REGIONAL REVIEW NOTIFICATION

ARC REVIEW CODE: R1803051

Name of Proposal:1350 West Marietta Street (DRI 2774)Review Type:DRISubmitting Local Government:City of AtlantaDate Opened:Mar. 5, 2018Deadline for Comments:Mar. 20, 2018Date to Close:Mar. 26, 2018*

703700A\De\Zoning\1703700A - Site-Zone-2.dwg - JonHoward - 02/20/2018

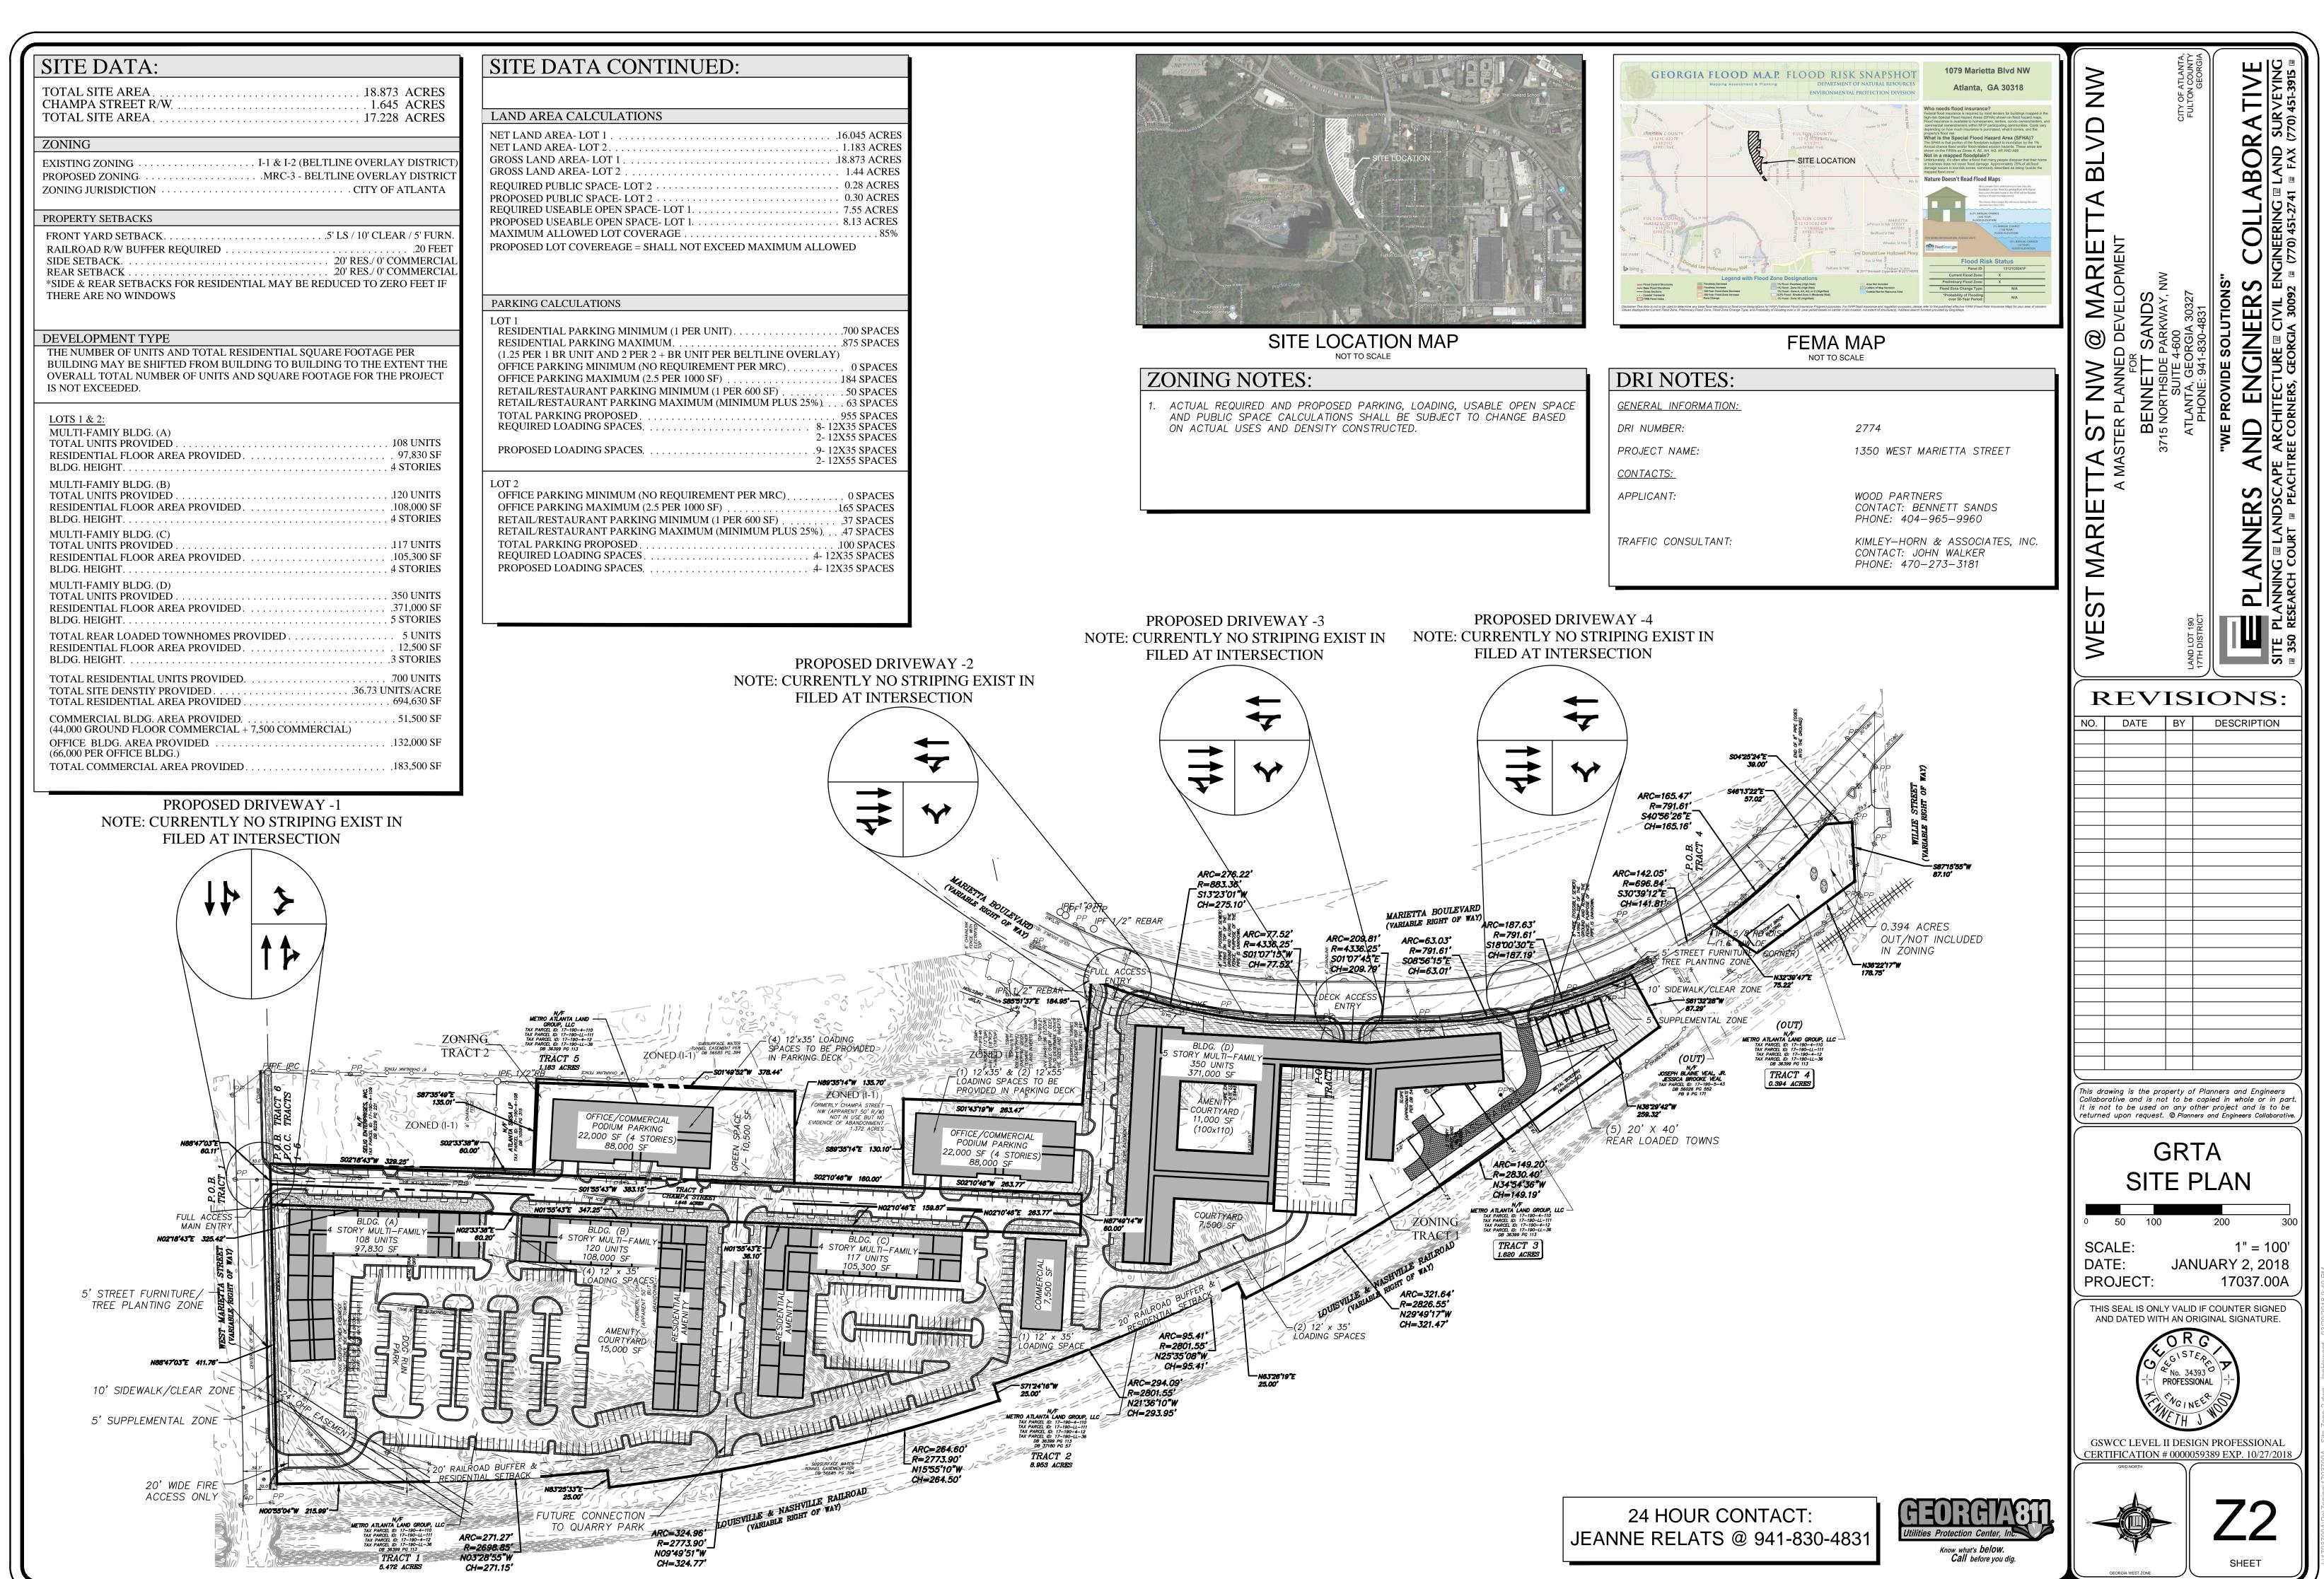
Additionally, ARC recommends that the development reserve space for and/or otherwise support future connectivity (bike/ped at minimum) under or over the CSX rail line to the planned Westside Reservoir Park to the west, as is shown on the DRI site plan. It is also recommended that the development reserve space at its eastern edge to link the aforementioned Park connection to a future extension of Church Street from the east, across Marietta Boulevard. This area is shown on the DRI site plan as green space. Allowing for this connection would support the LCI plan vision, offer connectivity to the nearby Howell Station neighborhood, and create an important entry point to the Park from Marietta Boulevard and points east.

The development proposes an access point West Marietta Street, a local road. The development does not indicate provisions for stub outs to adjacent parcels.

The development proposes pedestrian facilities throughout the development. No bicycle facilities are proposed internally.

The site plan indicates internal sidewalks that connect to existing sidewalks on Marietta Blvd and proposed sidewalks along West Marietta Street.
